Insertion tool for piston sealing ring of FO pump, puncture valve

Engine Type: L/S 50-60MC(E)

Puncture valve complete

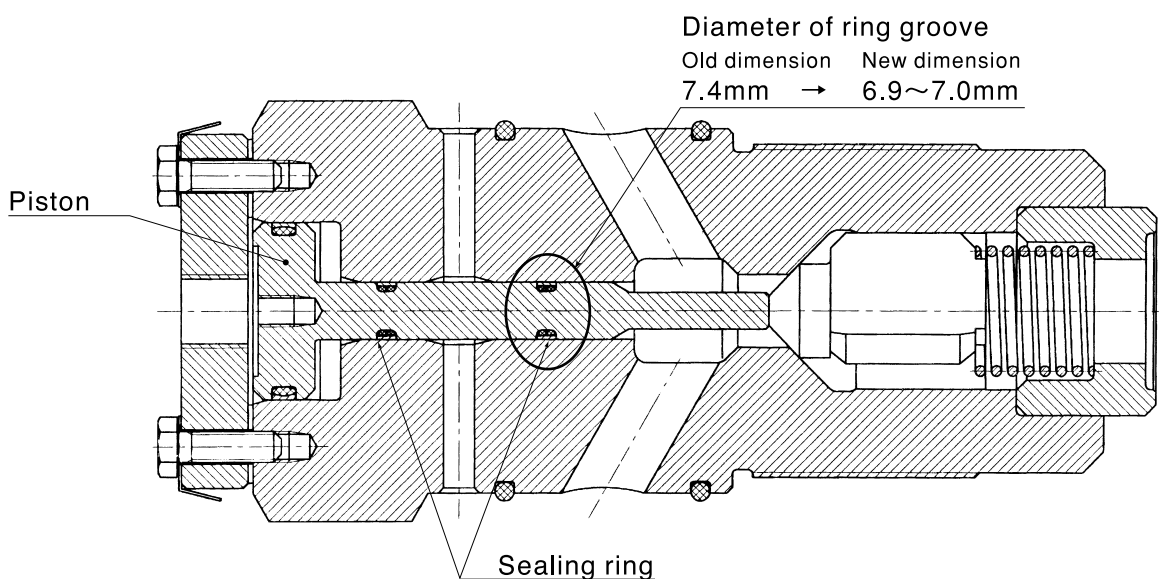
In order to make piston movement on smoothly, groove size is now modified.
At purchasing this insertion tool for piston sealing ring, we recommend you to
also purchase the latest type piston, if the old type piston is fitted to the vessel.
